Architect's Supplemental Instructions

PROJECT (Name and address):
New Offices for Hidalgo County Pct
2 and other County Offices
Pharr, Texas

**ARCHITECT'S SUPPLEMENTAL
INSTRUCTION NO:** 014

Work Changes Proposal Request

ADMINISTRATION BUILDING
ELECTRICAL RISER DIAGRAM

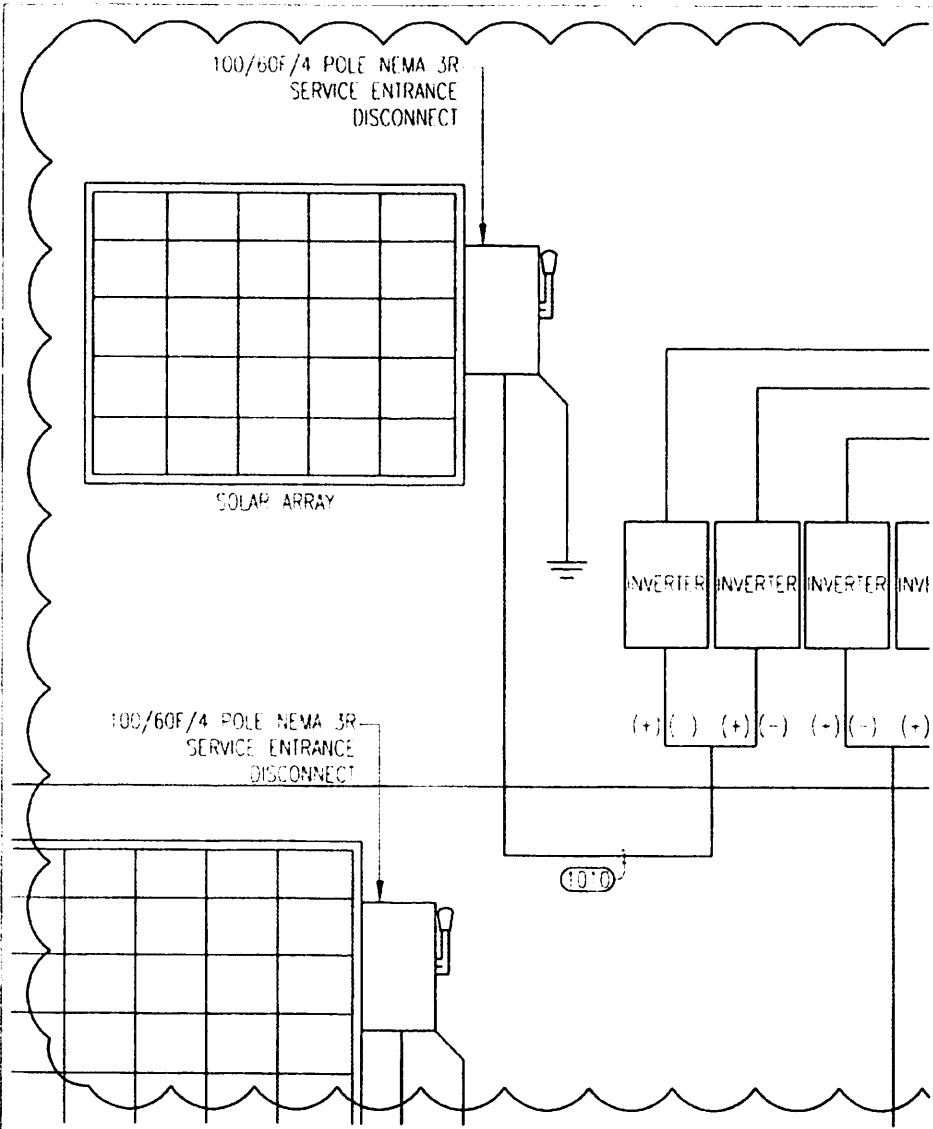
- Item 1 Sheet MEP-01. Remove reference to Keyed Note #3. Controls conduit to each wind turbine is not required.
- Item 2 Sheet E-13. Refer to revised Riser Diagram which includes four inverters. Refer to attached drawing.
- Item 3 Sheet E-14. Refer to revised Feeder/Branch Circuit Schedule. Refer to attached drawing.
